Approved East Elevation

NMA East Elevation

Purpose of Non-Material Amendment Application

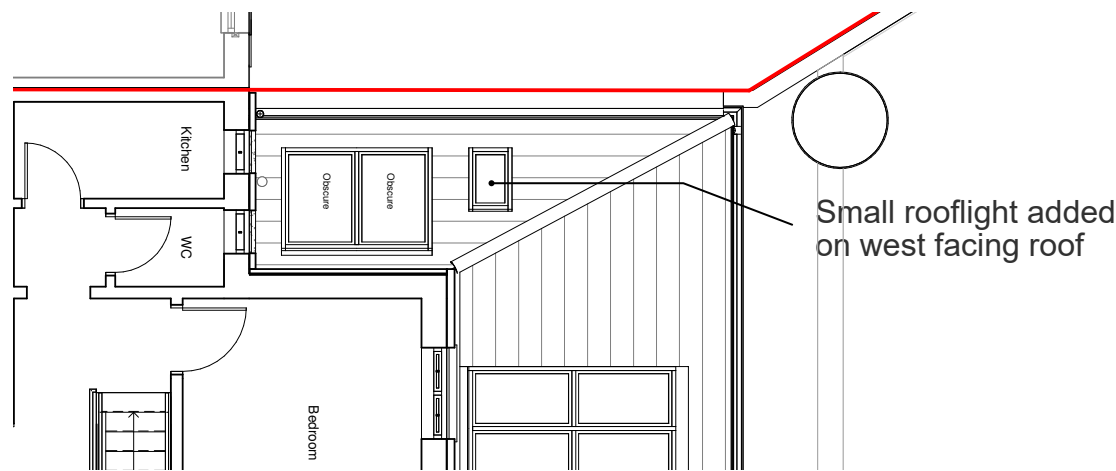
Existing kitchen window to be re-used in east porch

The purpose of this Non-Material Amendment application is to make design alterations to the east facing window and rooflight configuration. Specifically, the applicant seeks approval to the re-use of an existing six panel window instead of the approved four panel window. A three panel rooflight would be positioned above instead of the approved two panel rooflight.

This amendment revert to the configuration which was part of the original planning submission. Regarding the appropriateness of this window configuration, the applicant suggests that a six panel window is better aligned with the existing character and the reading of the elevation. The agent agrees that large windows typically signal principle rooms at ground floor and a porch element would typically have more glass. This amended design would benefit from the ability to re-use the existing kitchen window form the northern elevation.

The other minor amendment of approved drawings is the addition of a small rooflight on the west facing hipped roof. All other areas of the proposals remain as approved.
